# URBAN DESIGN COMMISSION APPLICATION UDC

Title: 999 Park

To: Urban Design Commission  
City of Madison Planning Division

999 S. PARK STREET | UDC RESUBMISSION | MARCH 2026

**PREVIOUS**

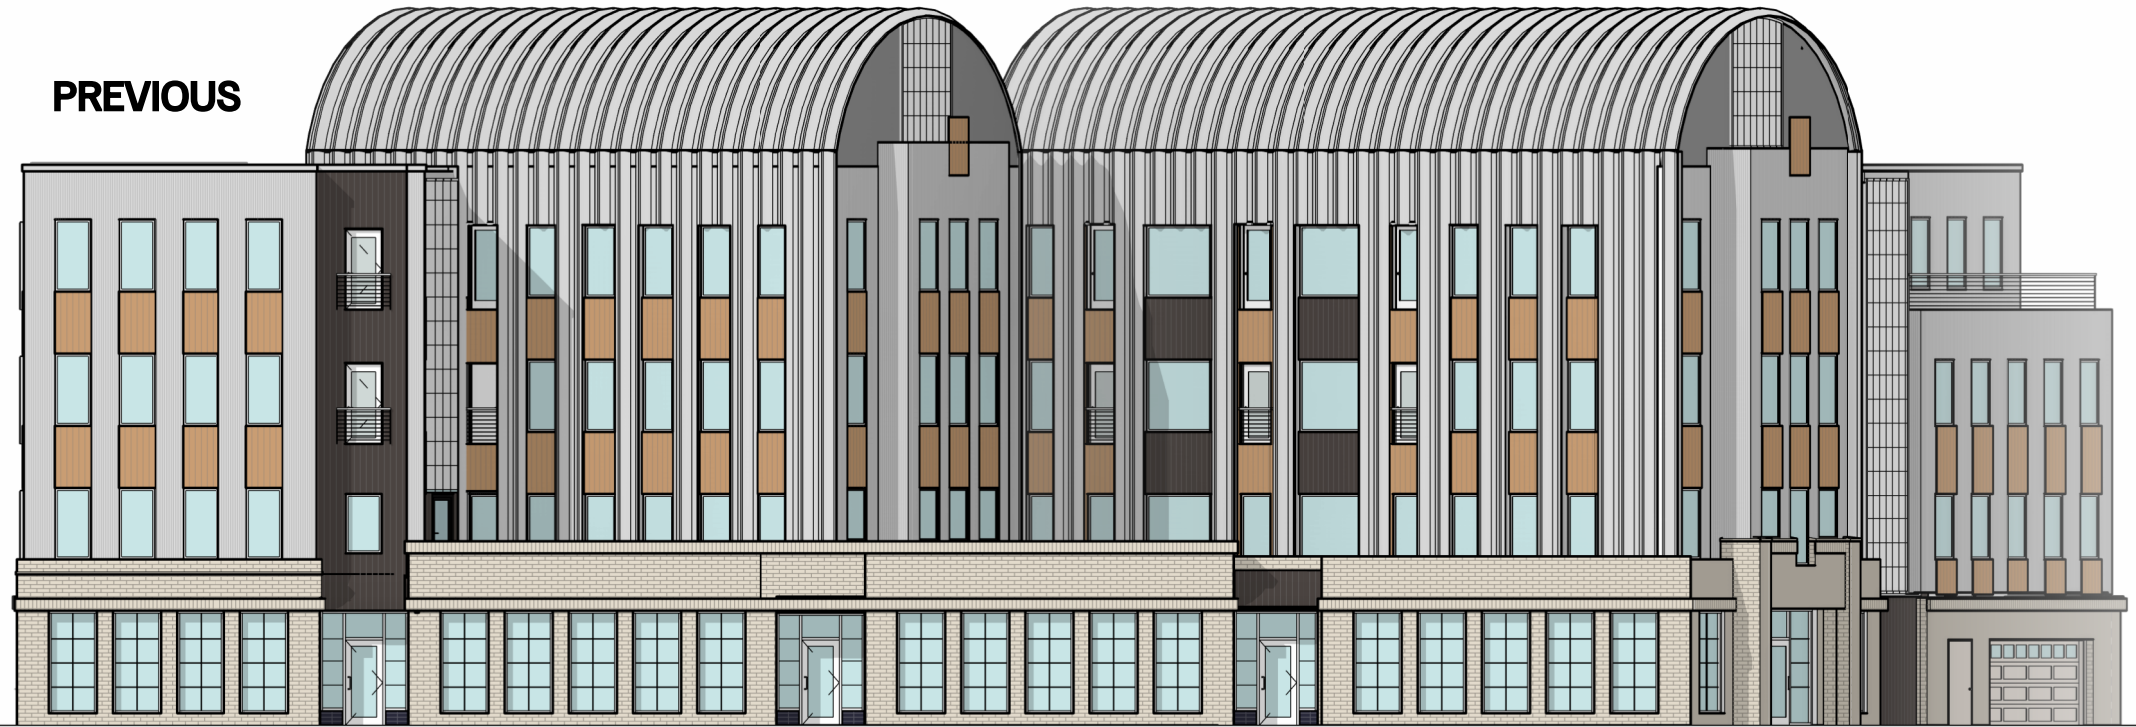
- REVISED WINDOW SIZES & RHYTHM TO MAKE CONSISTENT AROUND ENTIRE BUILDING.
- MATERIAL PALETTE SIMPLIFIED WITH WOODTONES. PALETTE APPLIED CONSISTENTLY AROUND ENTIRE BUILDING.
- ADDED SOLAR PANELS

**BUILDING DESIGNS | NORTH ELEVATION**

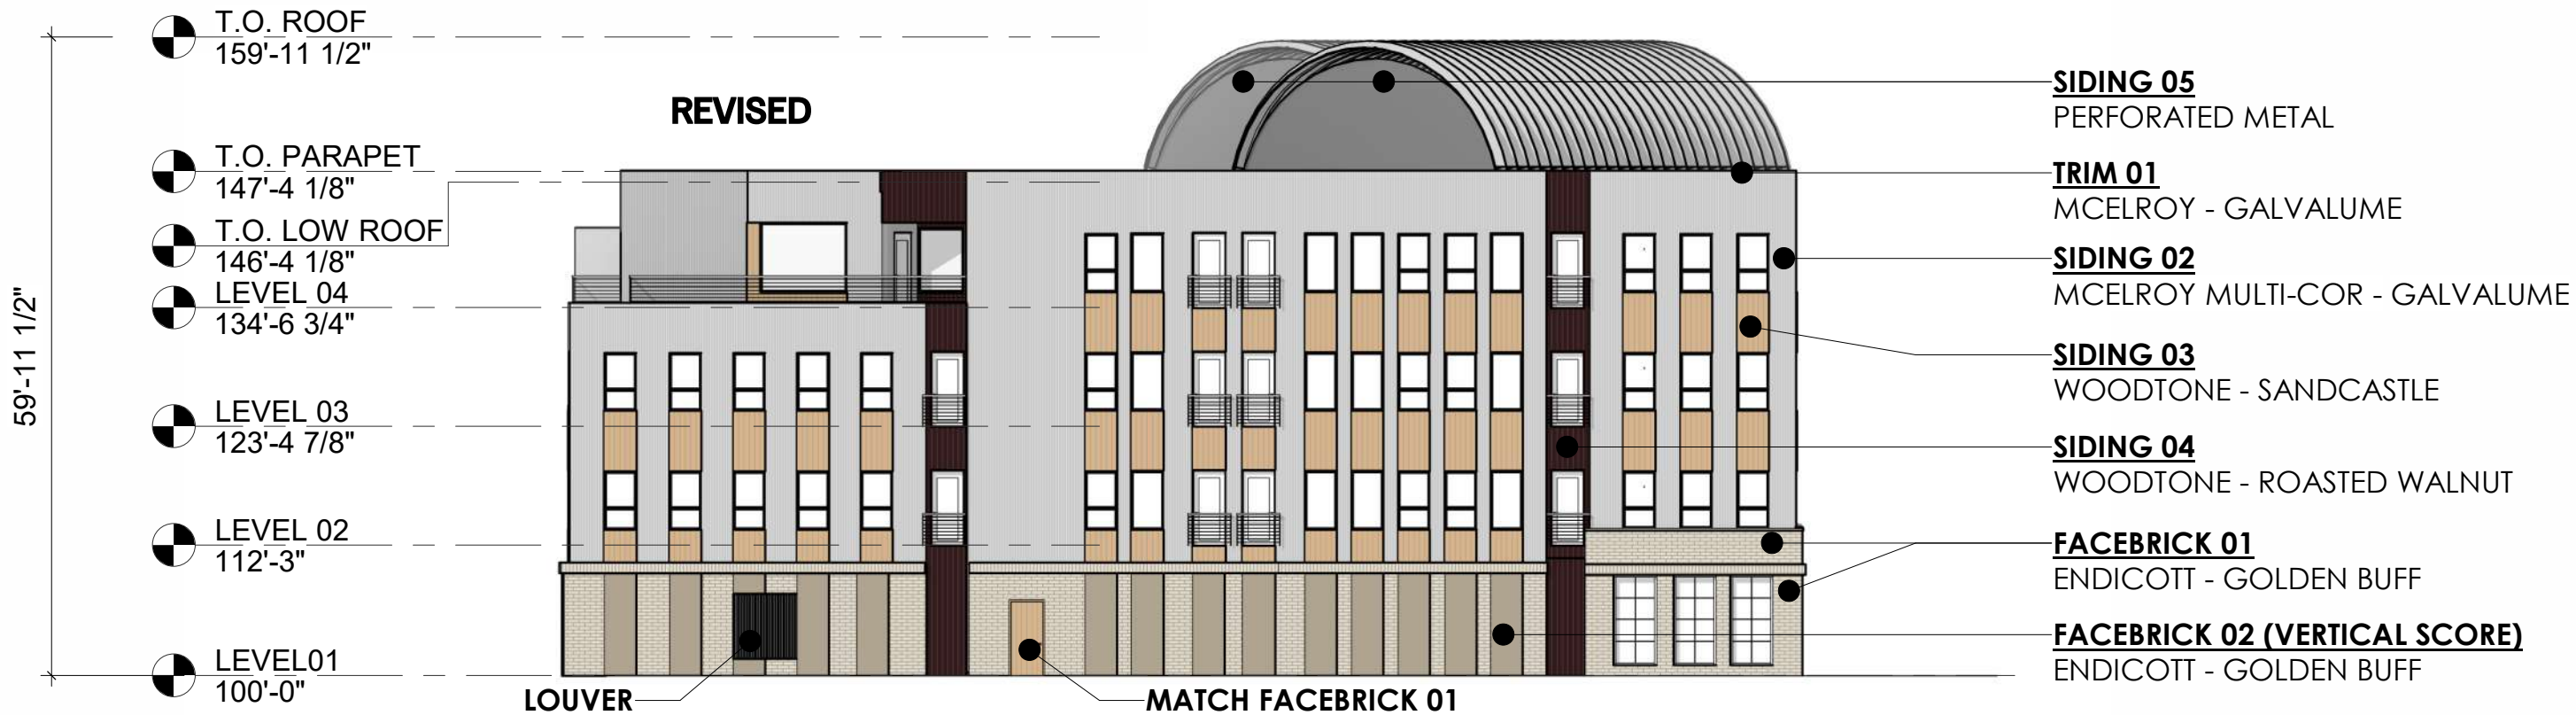
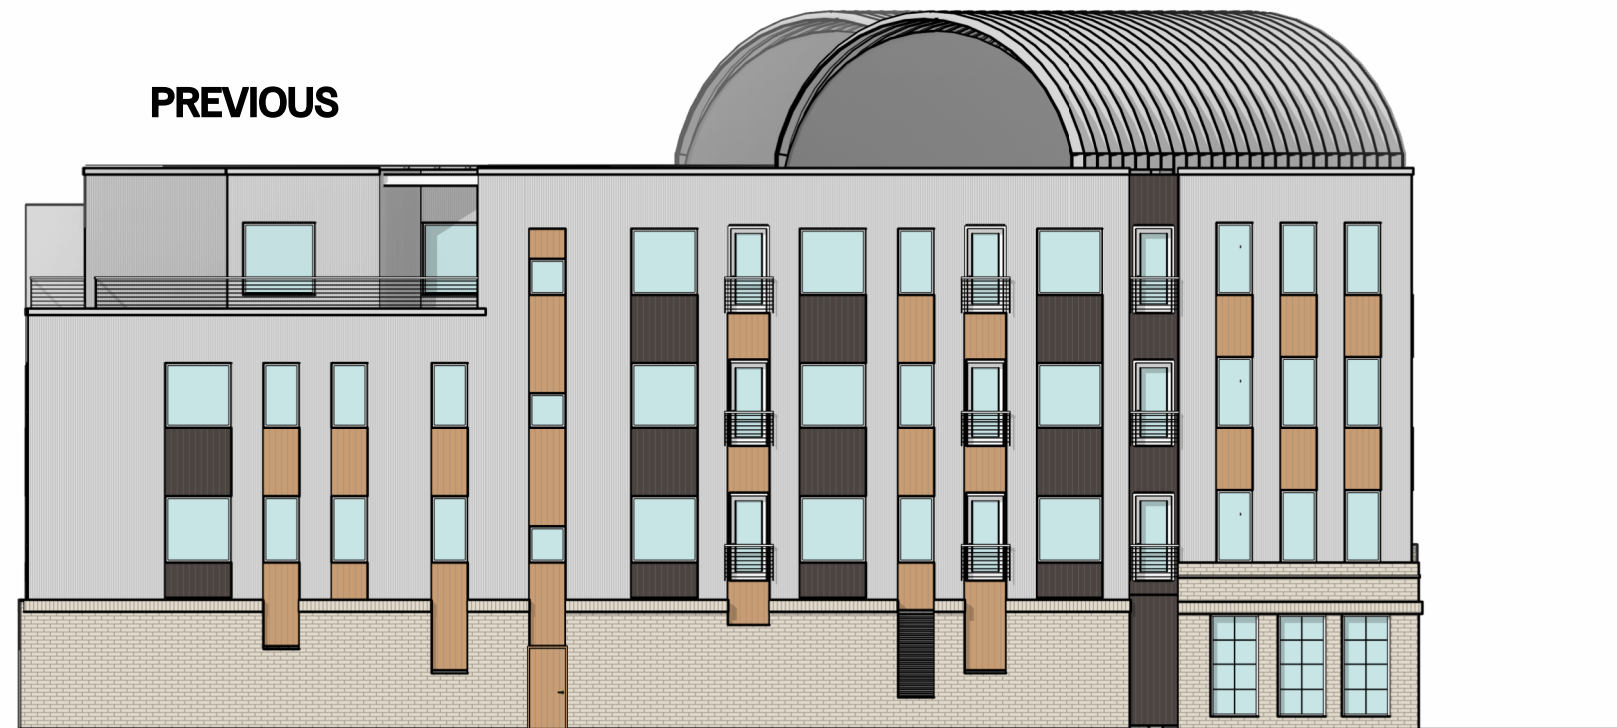
- REVISED WINDOW SIZES & RHYTHM TO MAKE CONSISTENT AROUND ENTIRE BUILDING.
- ADDED OPENINGS IN BLANK WALL AREAS WHERE AT A STAIRS.
- MATERIAL PALETTE SIMPLIFIED WITH WOODTONES. PALETTE APPLIED CONSISTENTLY AROUND ENTIRE BUILDING.

**PROPOSED**

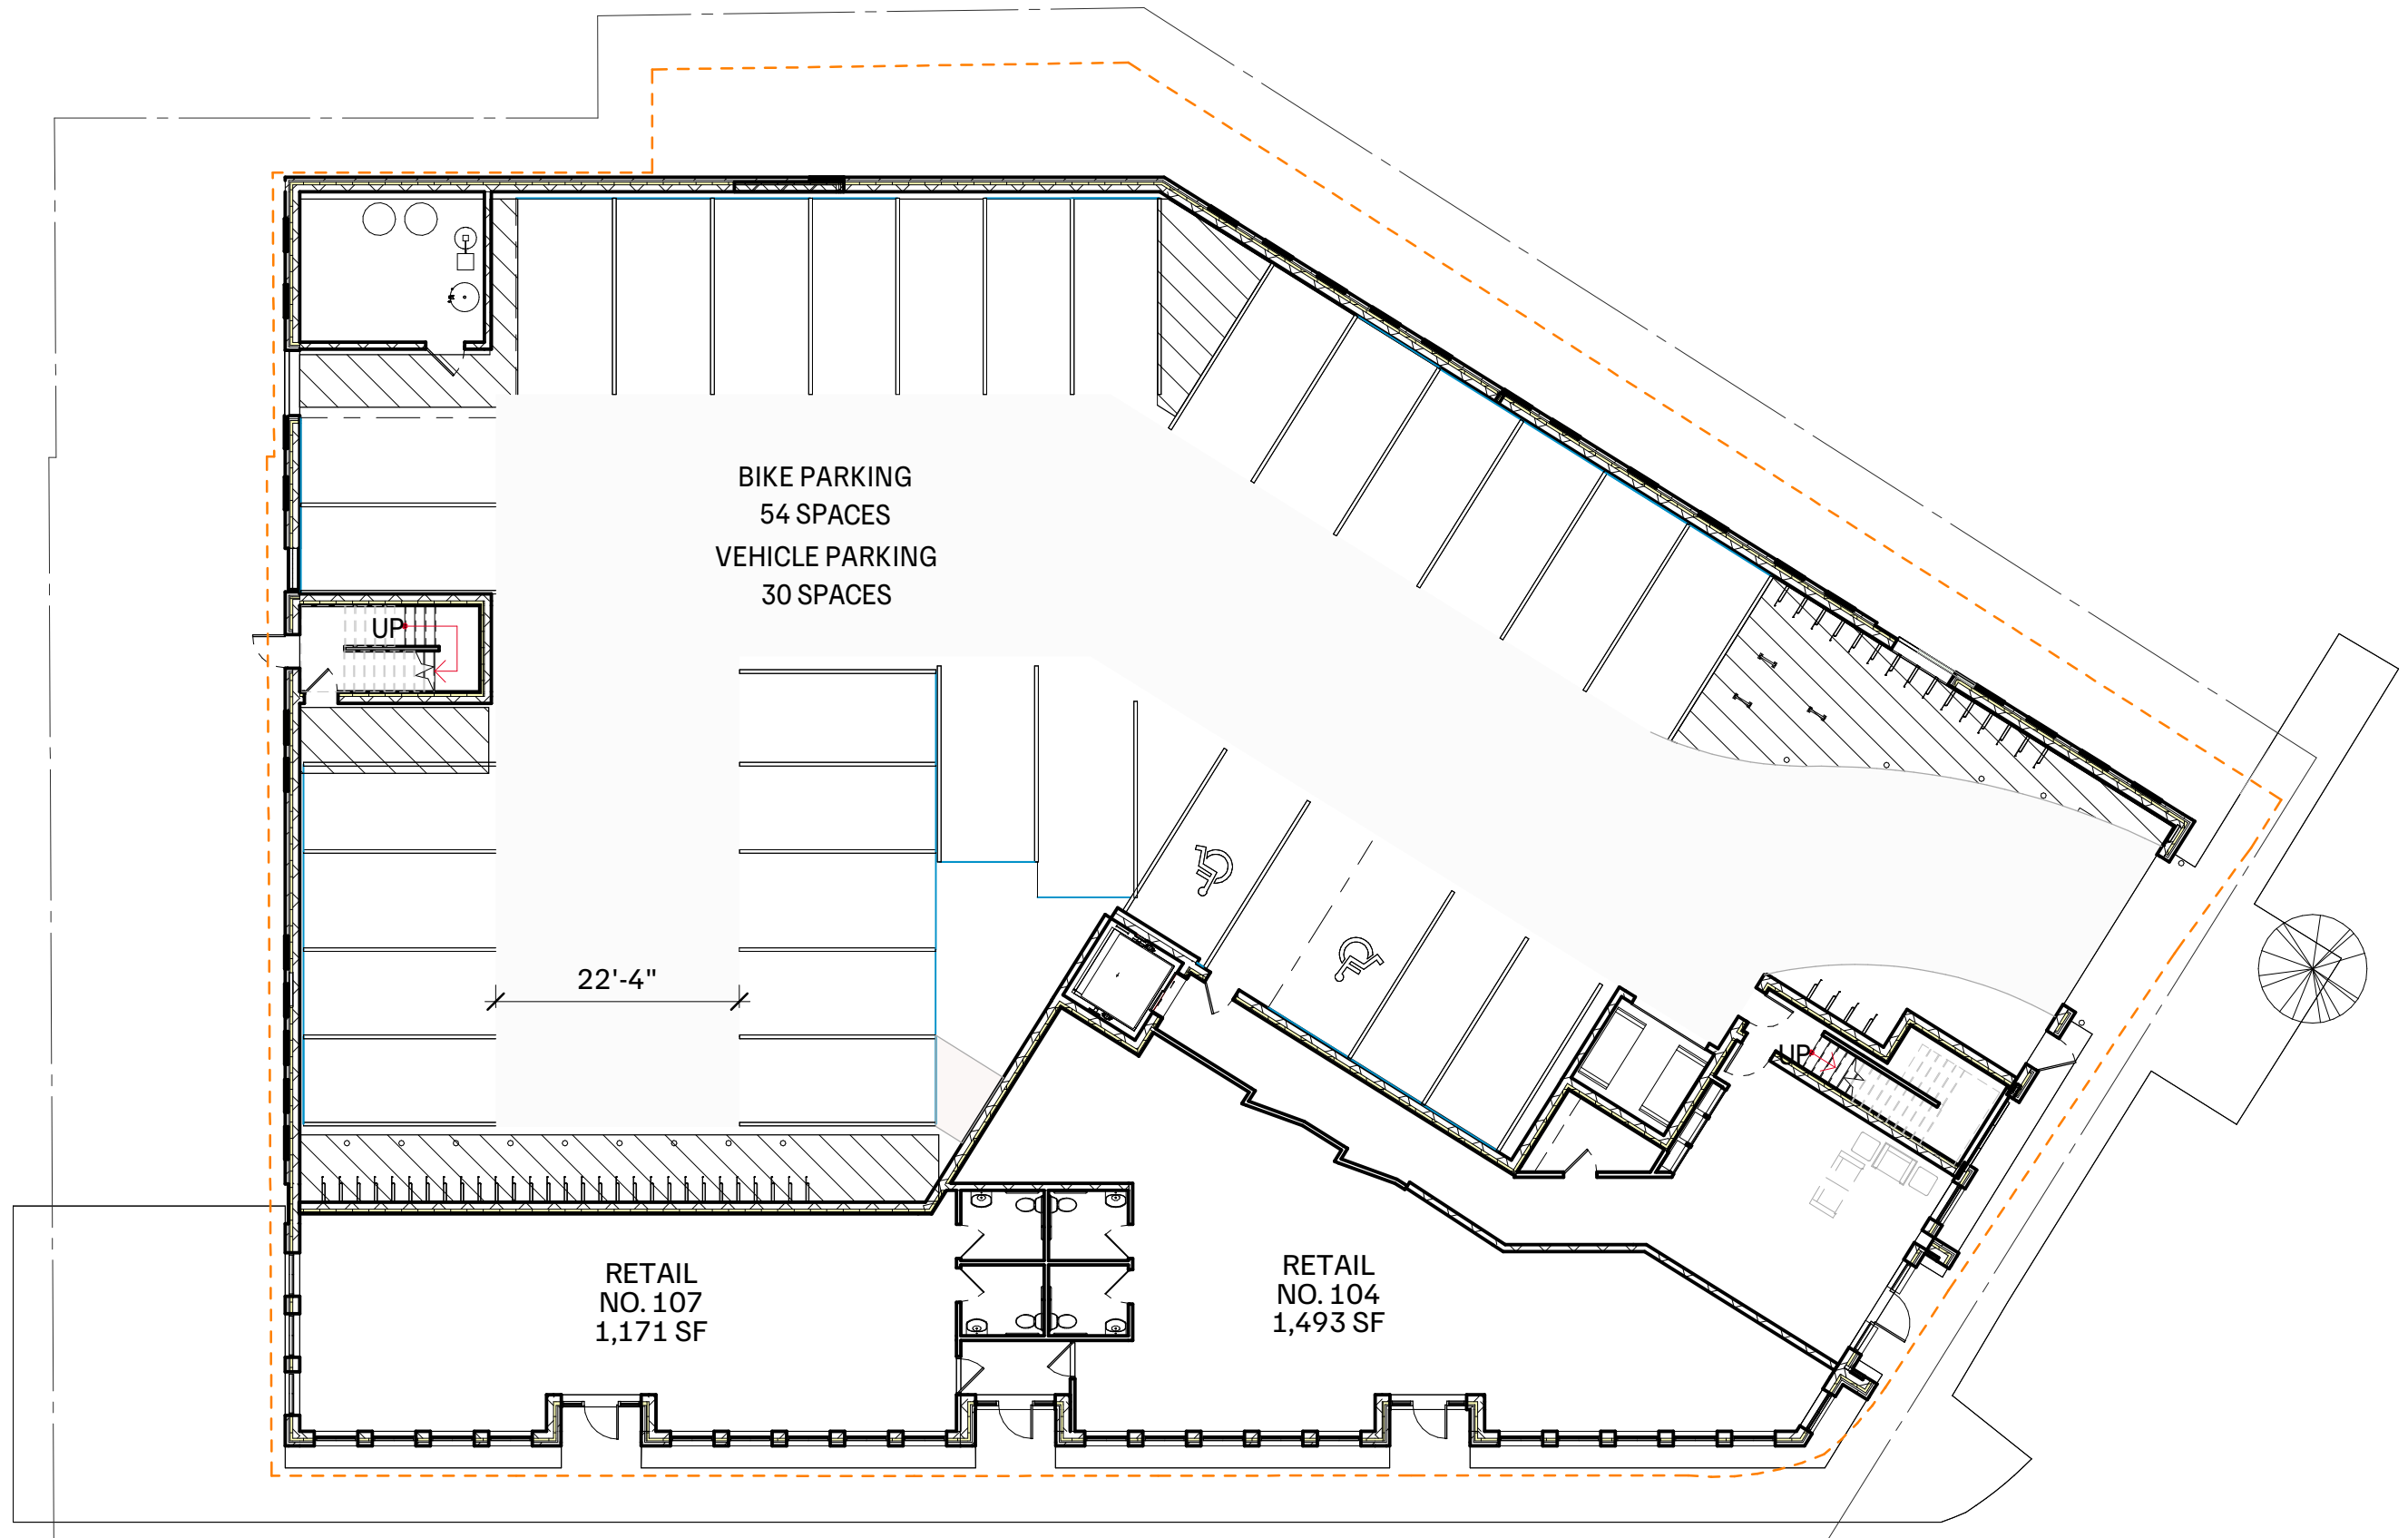
EXISTING WOOD FENCE  
(REFURBISHED)

REMOVE VINES AND  
OVER GROWTH
